N.C. DEPARTMENT OF TRANSPORTATION

Hydraulics Unit

Ditch Detail Changes

Changes to the Hydraulics V8 Workspace ditch details have been made to address deficiencies observed in the field, eliminate superfluous details, as well as make Hydraulics details correct and consistent with the Standard Drawings. (The Hydraulics ORD Workspace will be updated with the modified Details at a later date.)

Standard Base Ditch (riprap) (B > 6ft)

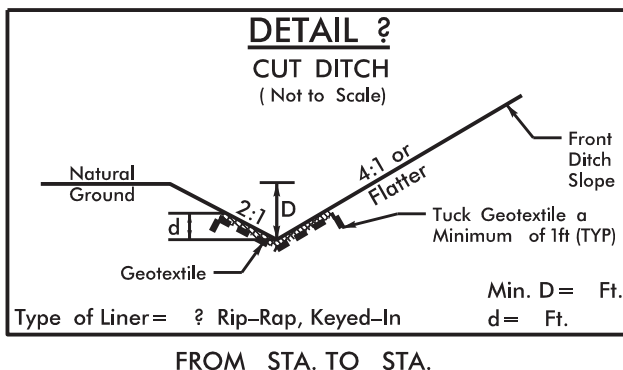
- Geotextile under riprap is tucked at the edges
- “Max. d” changed to “d” to prevent too little riprap from being placed
- Asterisk “*” has been clarified for when to use the < 6ft detail versus the >6ft detail
- Reference to Std Dwg 876.01 clarified. (Std Dwg 876.01 to 876.04 to be revised as well)

Cut Ditch (riprap)

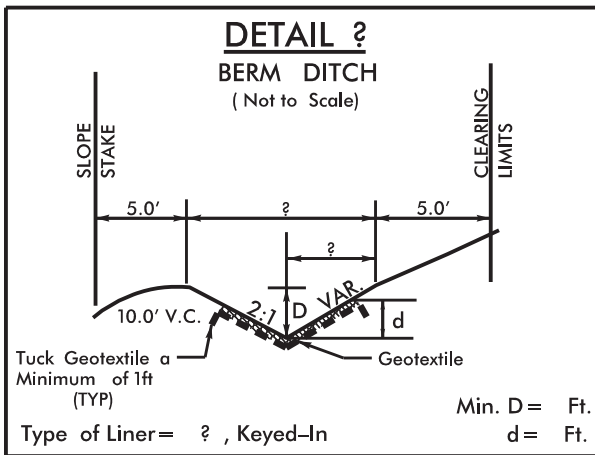
- Geotextile under riprap is tucked at the edges
- “Keyed-In” added to direct contractor to make riprap flush with ditch bottom
- “Max. d” changed to “d” to prevent too little riprap from being placed

Berm Ditch (riprap)

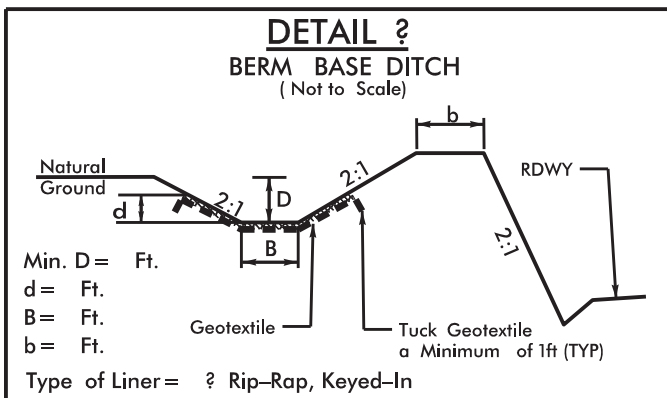
- Geotextile under riprap is tucked at the edges
- “Keyed-In” added to direct contractor to make riprap flush with ditch bottom
- “Max. d” changed to “d” to prevent too little riprap from being placed

Berm Base Ditch (riprap)

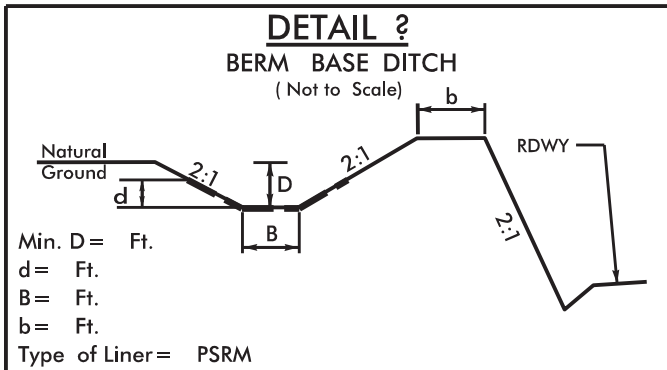
- Geotextile under riprap is tucked at the edges
- “Keyed-In” added to direct contractor to make riprap flush with ditch bottom
- “Max. d” changed to “d” to prevent too little riprap from being placed

Berm Base Ditch (PSRM)

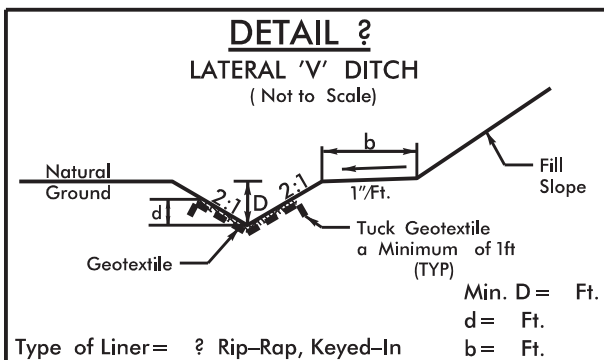
- “Max. d” changed to “d” to prevent too little PSRM from being placed

Lateral V Ditch (riprap)

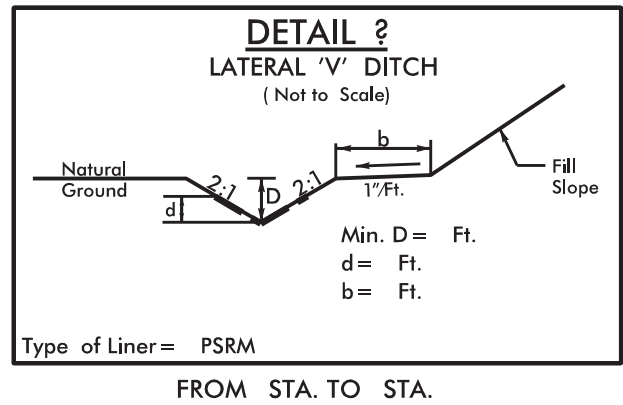
- Geotextile under riprap is tucked at the edges
- “Keyed-In” added to direct contractor to make riprap flush with ditch bottom
- “Max. d” changed to “d” to prevent too little riprap from being placed

Lateral Base Ditch (riprap) (B < 6ft)

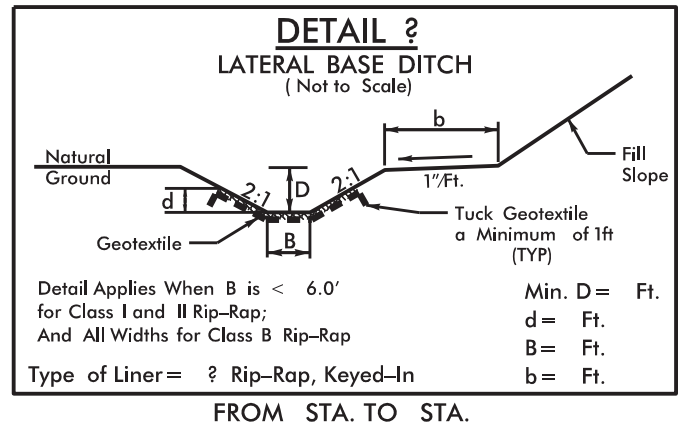
- Geotextile under riprap is tucked at the edges
- “Keyed-In” added to direct contractor to make riprap flush with ditch bottom
- “Max. d” changed to “d” to prevent too little riprap from being placed
- Asterisk “*” has been clarified for when to use the < 6ft detail versus the >6ft detail

Lateral Base Ditch (riprap) (B > 6ft)

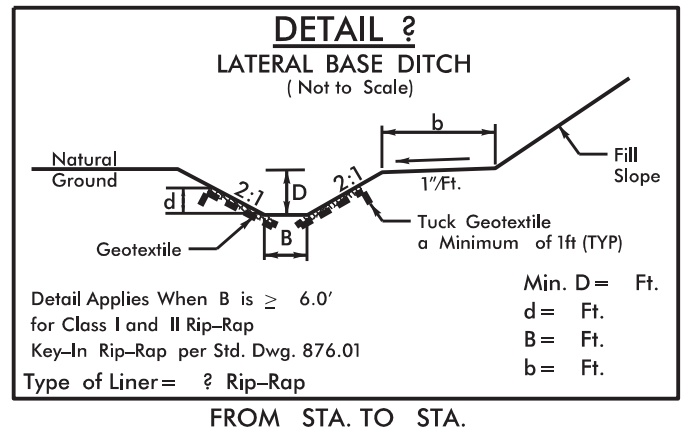
- Geotextile under riprap is tucked at the edges
- “Max. d” changed to “d” to prevent too little riprap from being placed
- Asterisk “*” has been clarified for when to use the < 6ft detail versus the >6ft detail
- Reference to Std Dwg 876.01 clarified. (Std Dwg 876.01 to 876.04 to be revised as well)

Lateral Base Ditch (PSRM)

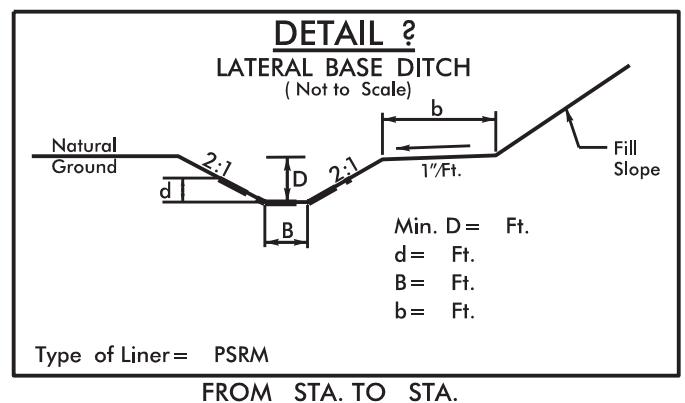
- “Max. d” changed to “d” to prevent too little PSRM from being placed

Special V Ditch

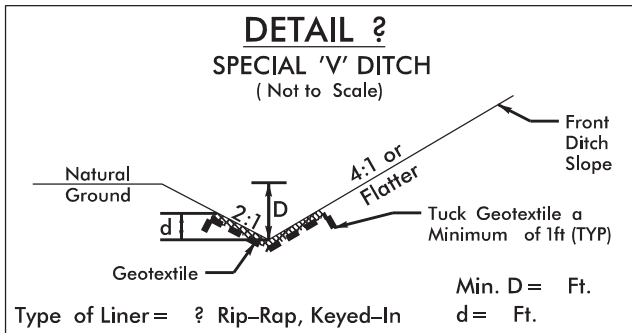
- This is a new detail which combines Special Cut Ditch and Special Lateral V Ditch

Special V Ditch (riprap)

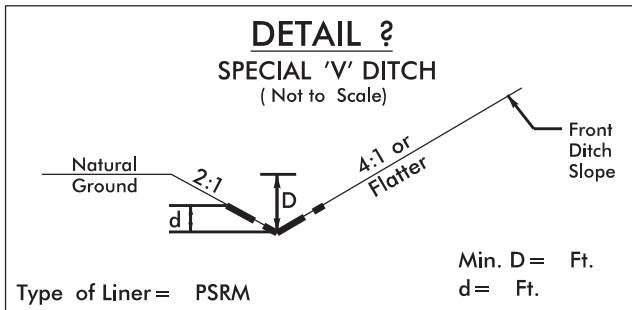
- This is a new detail which combines Special Cut Ditch and Special Lateral V Ditch
- Geotextile under riprap is tucked at the edges
- "Keyed-In" added to direct contractor to make riprap flush with ditch bottom
- "Max. d" changed to "d" to prevent too little riprap from being placed

Special V Ditch (PSRM)

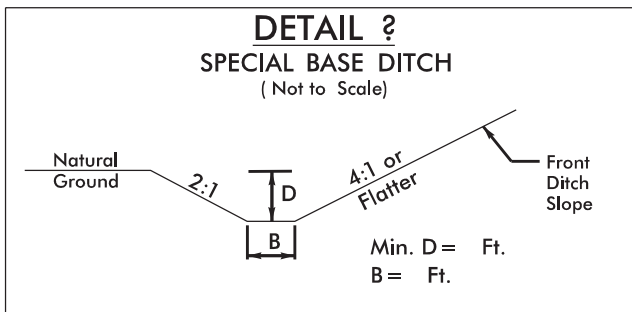
- This is a new detail which combines Special Cut Ditch and Special Lateral V Ditch
- "Max. d" changed to "d" to prevent too little PSRM from being placed

Special Base Ditch

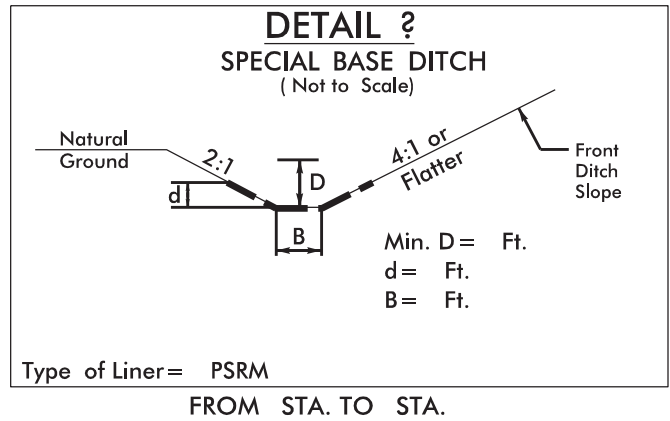
- This is a new detail which combines Special Cut Base Ditch and Special Lateral Base Ditch

Special Base Ditch (PSRM)

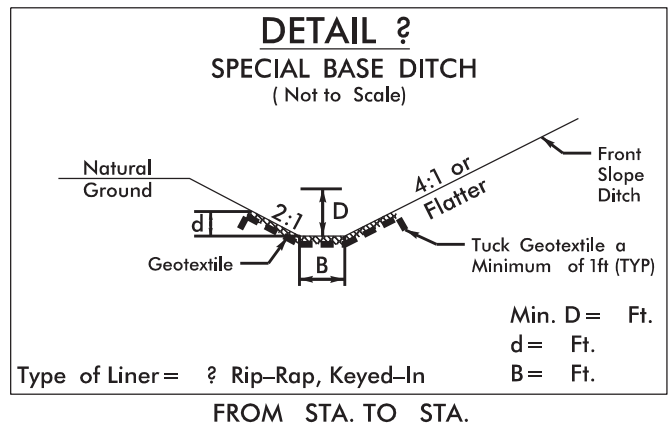
- This is a new detail which combines Special Cut Base Ditch and Special Lateral Base Ditch
- “Max. d” changed to “d” to prevent too little PSRM from being placed

Standard V Ditch (riprap)

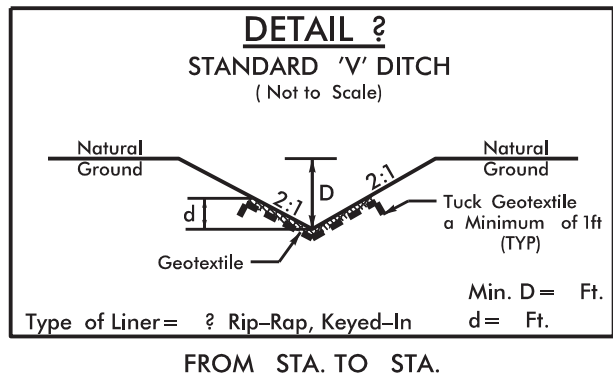
- Geotextile under riprap is tucked at the edges
- “Keyed-In” added to direct contractor to make riprap flush with ditch bottom
- “Max. d” changed to “d” to prevent too little riprap from being placed

Standard Base Ditch (riprap) (B < 6ft)

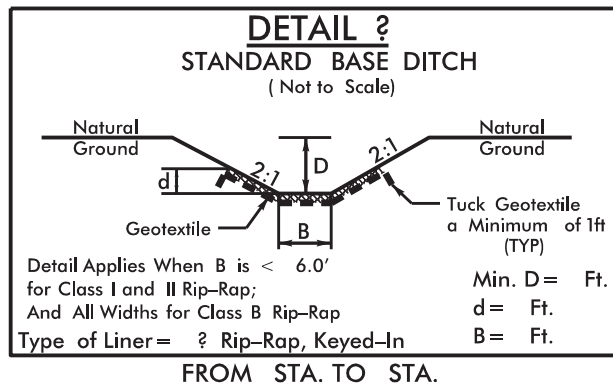
- Geotextile under riprap is tucked at the edges
- “Keyed-In” added to direct contractor to make riprap flush with ditch bottom
- “Max. d” changed to “d” to prevent too little riprap from being placed
- Asterisk “*” has been clarified for when to use the < 6ft detail versus the >6ft detail

Channel Change

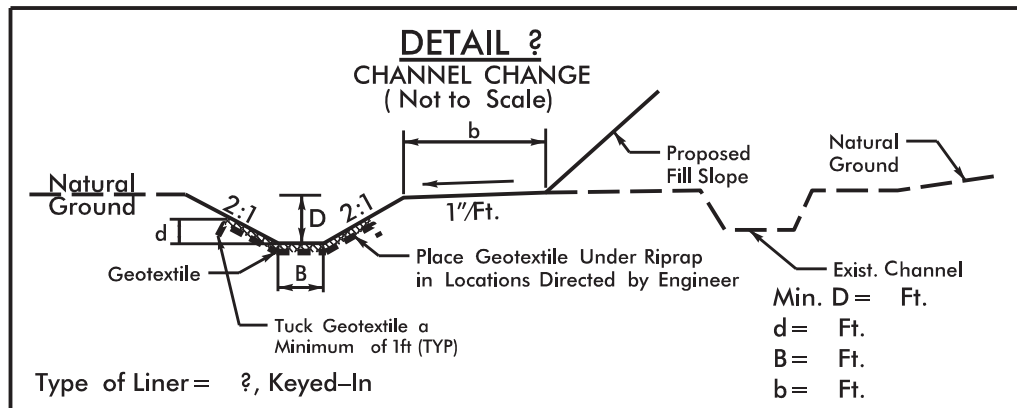
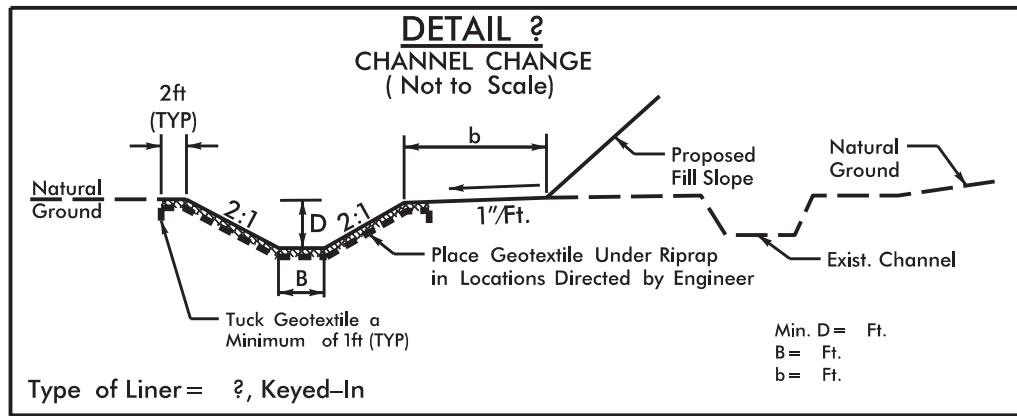
- Original detail has been split into two details. The difference between the two new details is the extent of riprap placement beyond the top of bank. Discuss which of the new details to use with the Division Environmental Officer and / or NEU staff.

- The detail with riprap beyond the top of bank does not contain a “d” for riprap height.
 - The detail with riprap within the top of bank contains a “d” for riprap height. “Max d” was changed to “d” to prevent too little riprap from being placed.

- For both new details:
 - Geotextile under riprap is tucked at the edges
 - “Keyed-In” added to direct contractor to make riprap flush with ditch bottom

- “Place geotextile under riprap in locations directed by engineer” added
 - There is not a uniform approach on whether to place geotextile only on the slopes, in the bottom of the channel, or not at all. This note allows the geotextile placement to be determined in the field.

Rip Rap at Embankment

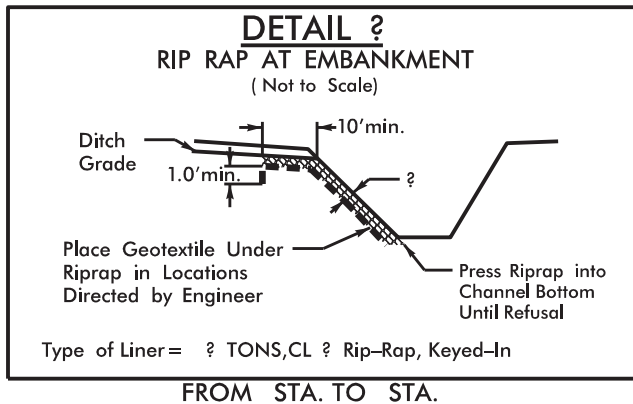
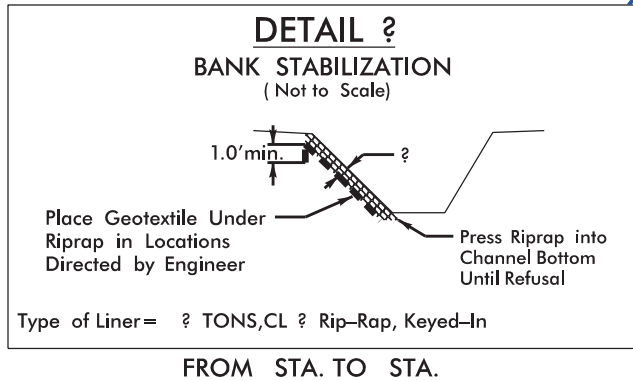
- Original Detail has been split into two details:
 - Bank Stabilization detail
 - Ditch at top of bank has been eliminated
 - Rip Rap at Embankment detail

- Ditch length at top of bank has been extended to improve relative scale of ditch to overall detail
- Changes to both new details:
 - “Place geotextile under riprap in locations directed by engineer” added.

- There is not a uniform approach on where to place geotextile. This note allows the geotextile placement to be determined in the field.
 - “Geotextile = ?SY” deleted. Since geotextile quantity is indeterminate, this note was removed. An estimated amount of geotextile will need to be included in the bid line items. This is similar to the Channel Change detail.

- “Press riprap into channel bottom until refusal” note added. This action prevents most stream bottom disturbance, while still allowing the toe of riprap to gain purchase to prevent slumping of the riprap slope.

- “Keyed-In” added to direct contractor to make riprap flush with bank.

Bank & Scour Hole Stabilization

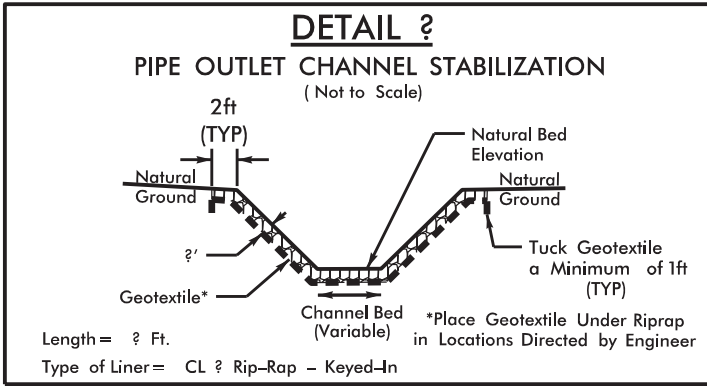
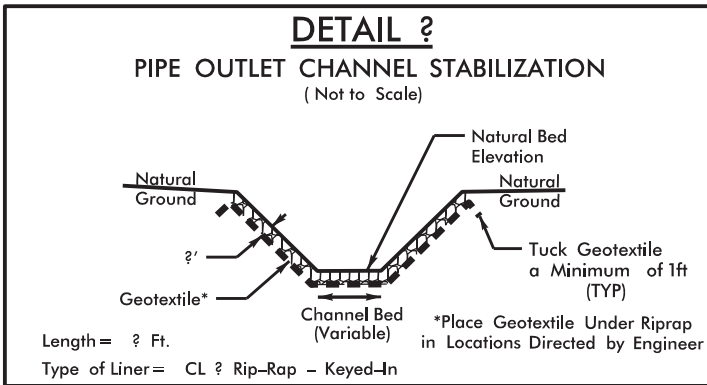
- Original detail has been split into two details. The difference between the two new details is the extent of riprap placement beyond the top of bank. Discuss which of the new details to use with the Division Environmental Officer and / or NEU staff.
- Changes to both new details:
 - “Place geotextile under riprap in locations directed by engineer” added There is not a uniform approach on where to place geotextile. This note allows the geotextile placement to be determined in the field.
 - Geotextile under riprap is tucked at the edges.
